DEVIATION REQUEST AND DECISION FORM

| Project Name : | Crossroads North |

A deviation from the standards of or in Appendix F, Standard Drawings, **SD 2-3, Urban Non-Residential Collector** and **Table 2-7. Roadway Design Standards for Urban Collectors and Locals-** of the Engineering Criteria Manual (ECM) is requested.

TYPICAL INTERNAL DRIVES (PRVT) 36' MAT (STRIPED MEDIAN)
SCALE: NTS

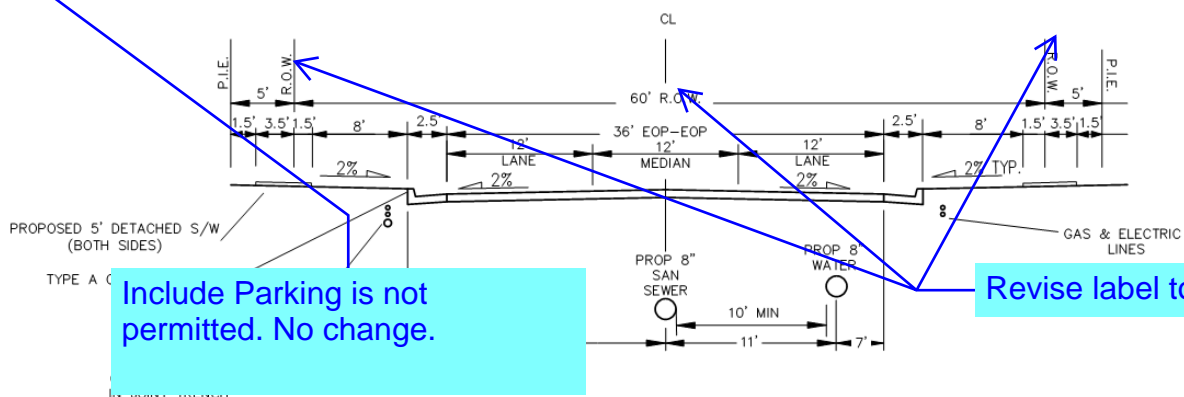
Staff recommends revising the last bullet point to allow direct lot access in conformance with ECM Section 2.4 for Lots 4 through 9 onto Pro Omnibus Height.
